**Re: Ontario Power Generation Inc.
2017-2021 Payment Amounts
Ontario Energy Board File Number EB-2016-0152**

**OEB Staff Interrogatories
Ontario Power Generation Inc. (OPG)
2017-2021 Payment Amounts
EB-2016-0152
September 26, 2016**

Ref: Exh A1-3-3 Chart 1

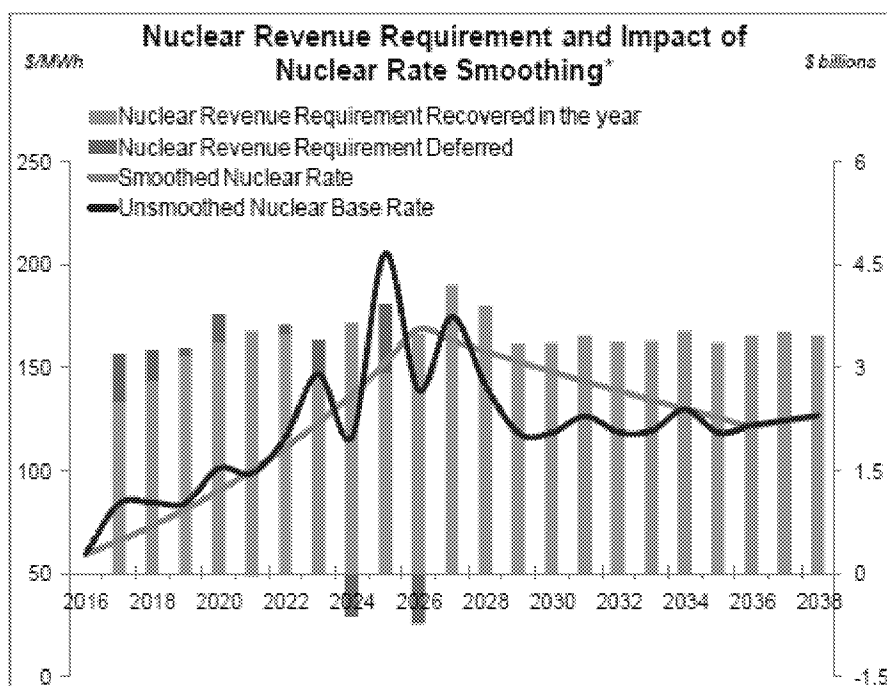
The 2016-2018 business plan states that nuclear rate smoothing will moderate price spikes during DRP and eventual Pickering closure period, and the following graph is provided in the business plan.
